LETTER AND RESPONSE TO REGULATOR COMMENTS ON FOURTH FIVE-YEAR REVIEW  
REPORT NIROP FRIDLEY MN (PUBLIC DOCUMENT)  
9/27/2013  
TETRA TECH

Subject: Responses to Comments - Fourth Five-Year Review Report  
NIROP Fridley, Fridley, Minnesota

**RESPONSES TO EPA COMMENTS ON THE FOURTH FIVE-YEAR REVIEW  
REPORT  
DATED MAY 2013**

**NAVAL INDUSTRIAL RESERVE ORDNANCE PLANT  
FRIDLEY, MINNESOTA**

**EXHIBIT 2**  
**DESIGNATED RESTRICTED AREAS**  
**NAVAL INDUSTRIAL RESERVE**  
**ORDNANCE PLANT**  
**FRIDLEY, MINNESOTA**

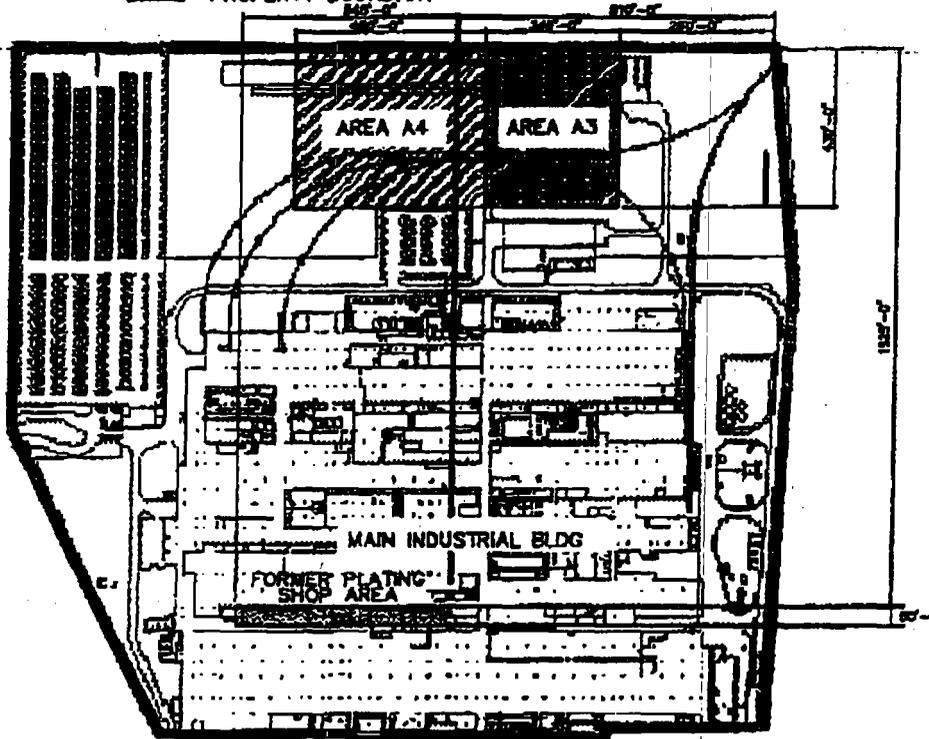
**10. Comment:** The Fourth 5YRR does not include a figure showing the locations where land use controls (LUCs) apply (i.e., Designated Restricted Areas, North 40, or Former Plating Shop). While Figure 3-1 (Site Plan) and Attachment 3 (TCE Isoconcentrations Maps and Approximate Capture Zone Configurations) figures indicate where OU2, OU3 and the approximate location of the East Plating Shop (i.e., Former Plating Shop) are located, a figure showing the specific locations where LUCs apply is not included. Revise the Fourth 5YRR to include a figure showing the specific locations where LUCs apply.

**Response:** The Five-Year Review does contain this information; it is located in Attachment 2, following the Site Inspection Checklist.

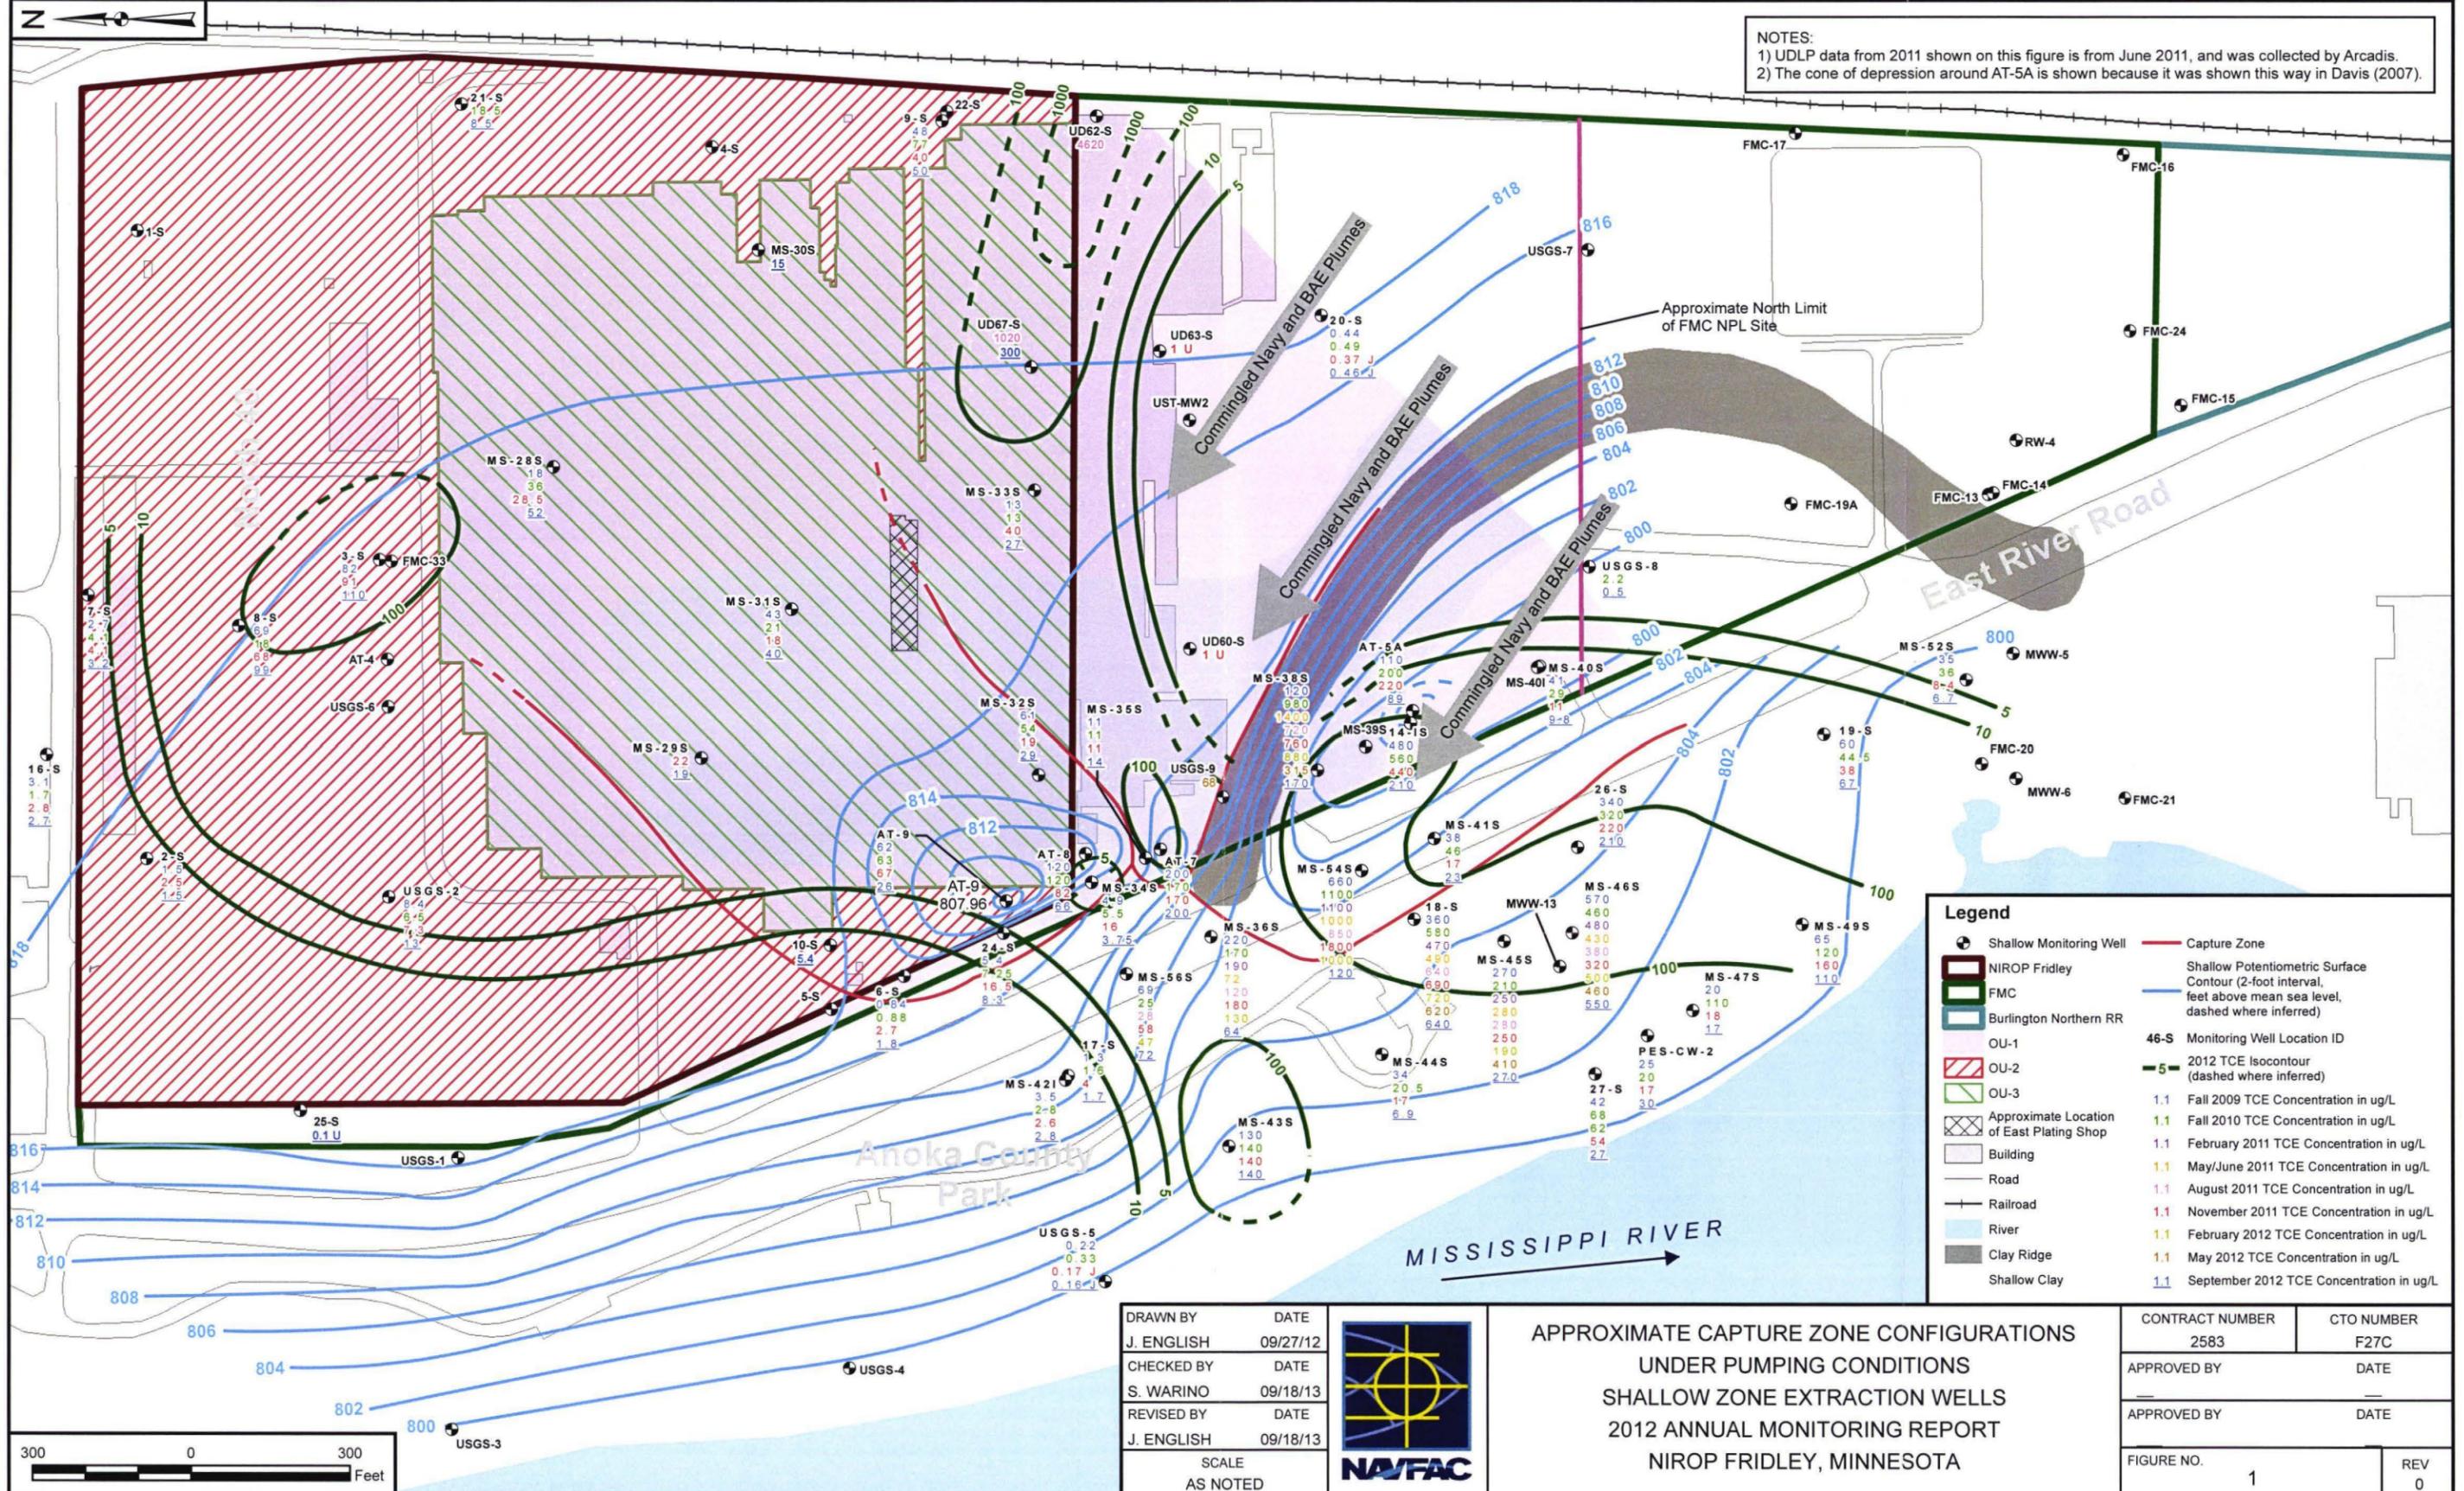
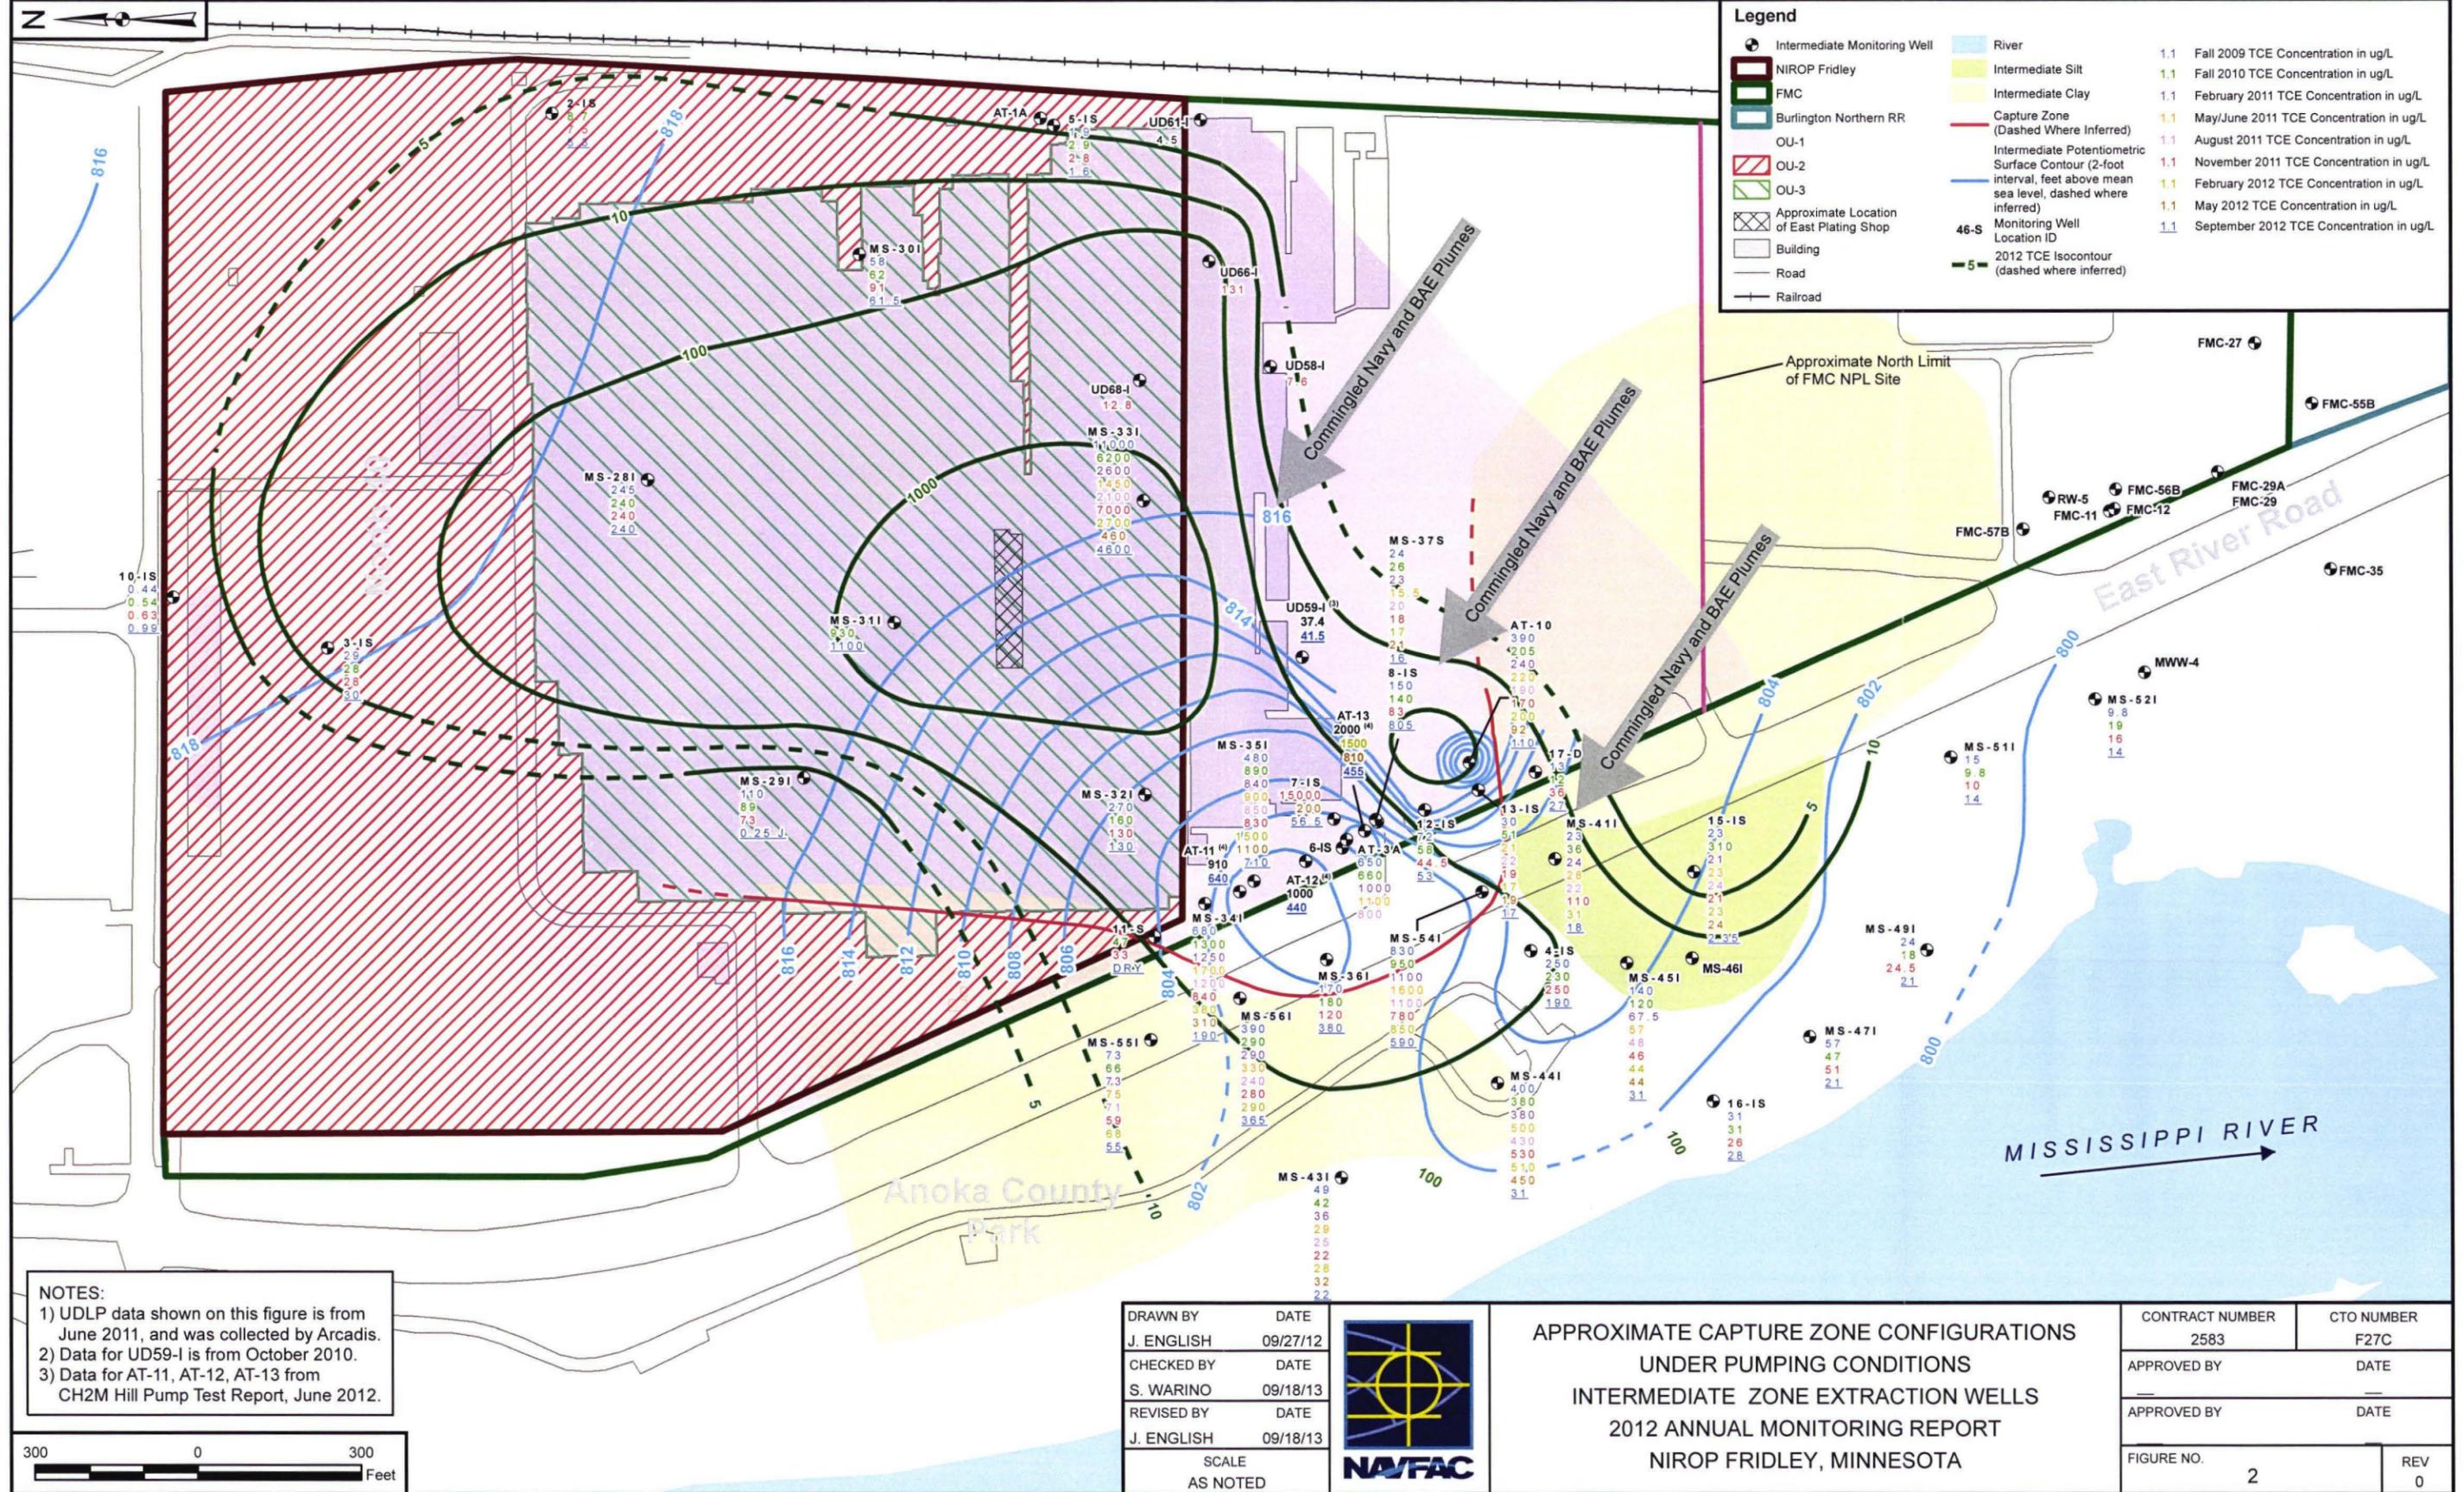
**12. Comment: Section 7.2.5.1, Problem B: Effectiveness of the Capture Well System, Page 7 of 9:** The last sentence of Section 7.2.5.1 references Attachment 3 as support that the system continues to show significant improved performance; however, Attachment 3 (TCE Isoconcentration Maps and Approximate Capture Zone Configurations) includes TCE isoconcentration maps and the approximate capture zone configurations. These do not show significant improved performance of the system. Revise Section 7.2.5.1 to reference figures and tables which support that the system continues to show significant improved performance.

**Response:** The following text has been added just before the reference to Attachment 3: “and effectiveness in capturing contaminated groundwater”. The figures are meant to show substantial capture of contaminated groundwater.
